BMP NUMBER: PC190

Bruces Super Body Shop

Stormwater Management/BMP Record Drawing and Construction Certification Review Tracking Form

Project: Brucs Super Body Shop
BMP Facility: Forebay onsite + downstream wet pond expanded
Plan No.: SP-72-01
Assigned County BMP ID Code: PC190 (Forebay) + PC042 (Downstream Wet Pond)

BRUCE'S SUPER BODY SHOP
TWO WET PONDS
BMP RECORD DRAWING PLAN

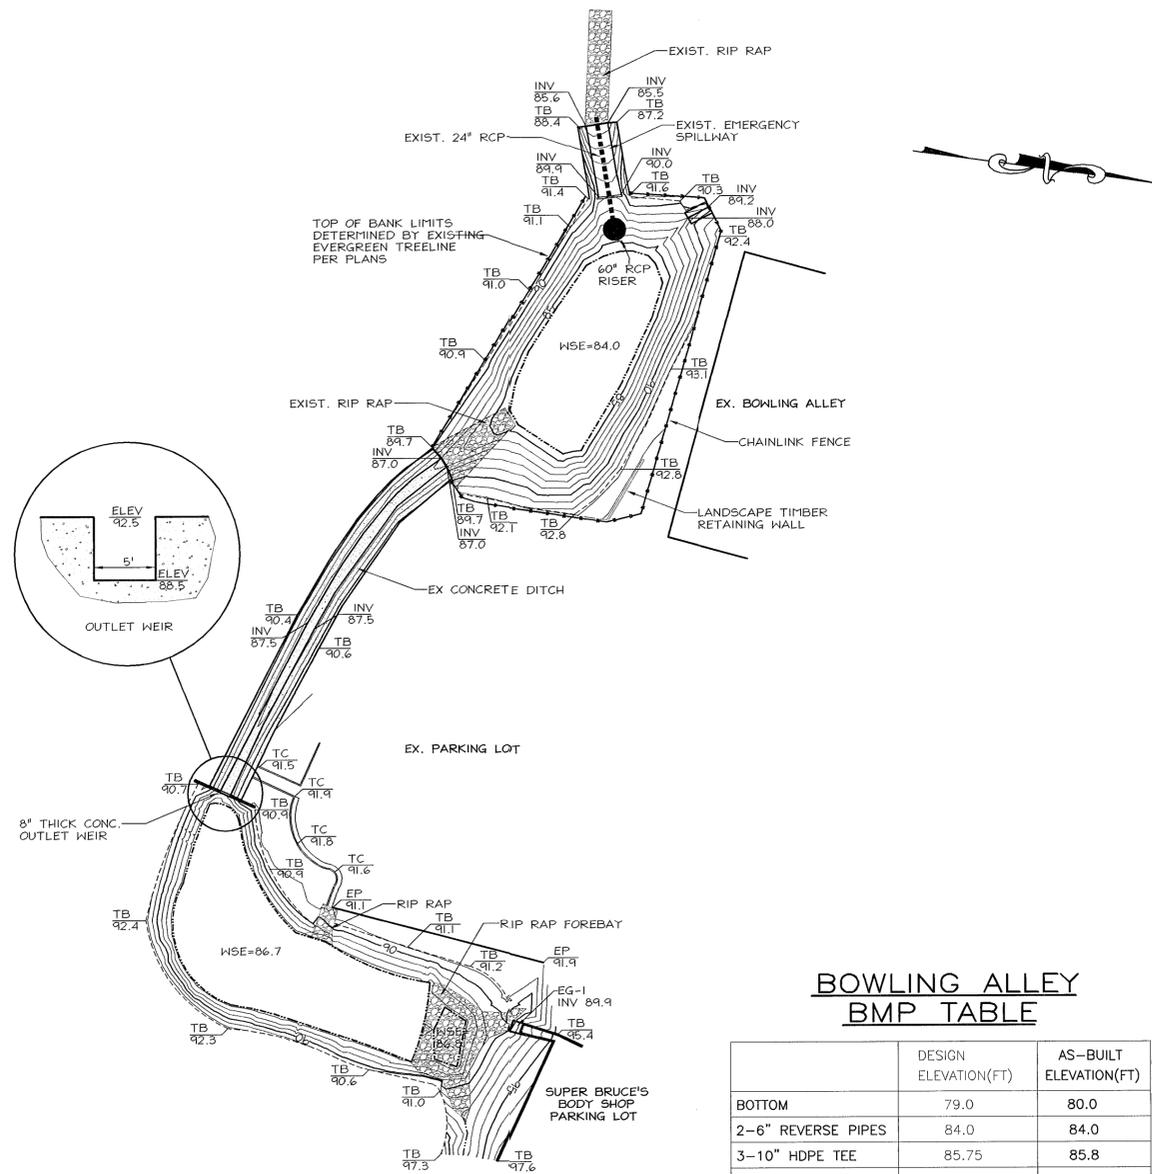
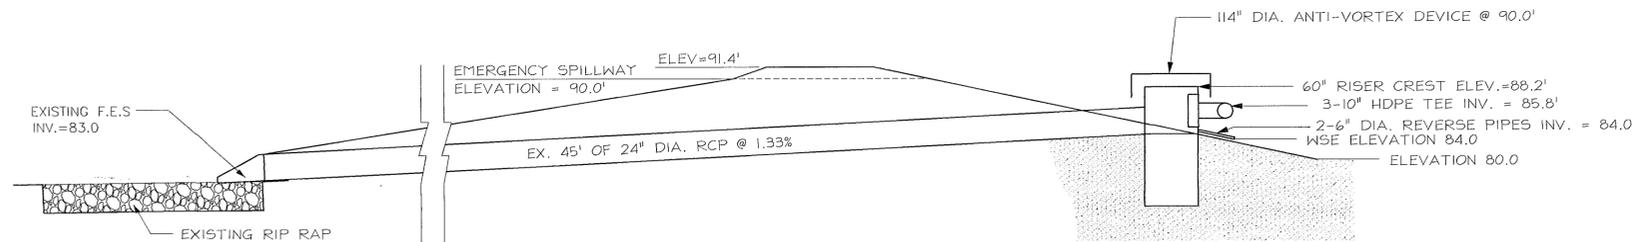
Note: The record drawing shows a 14,000 c.f. deficiency in volume required + the ~~enr~~ engineer refuses to certify that it was not built per the plan. Based on preliminary review it appears that the forebay + offsite (bowling) wet pond were not ~~deep~~ built deep enough. I will deal with that issue; however I need to know from the inspector(s) if there are limiting constraints to deepening the swm/bmp facilities. I would not have expected I had to know of this till the asbuilts were turned in.
